Cisco Unified IP Phone Release Notes for Firmware Release 8.4(1) (SCCP and SIP)

7971G-GE, 7970G, 7961G-GE, 7961G, 7941G-GE, 7941G, 7931G, 7911G, and 7906G

August 25, 2008

Figure 1 Cisco Unified IP Phone Screen Changes with Firmware Release 8.4(1)

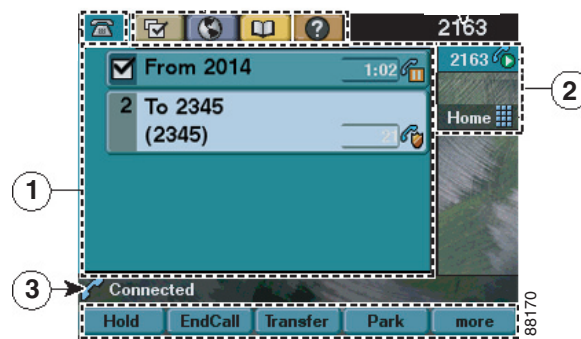
Cisco Unified IP Phone firmware release 8.4(1) introduces three significant appearance changes to the phones:

- Dynamic call window—Minimizes the amount of screen space obscured when an active call is present. See location 1 in [Figure 1 on page 5](#).
- Transparent line label—Minimizes the amount of screen space obscured when a line button has been provisioned with a text label. See location 2 in [Figure 1 on page 5](#).
- Transparent status message line—Minimizes the amount of screen space obscured by the phone status messages by changing from using a shaded background to shadowed text. See location 3 in [Figure 1 on page 5](#).
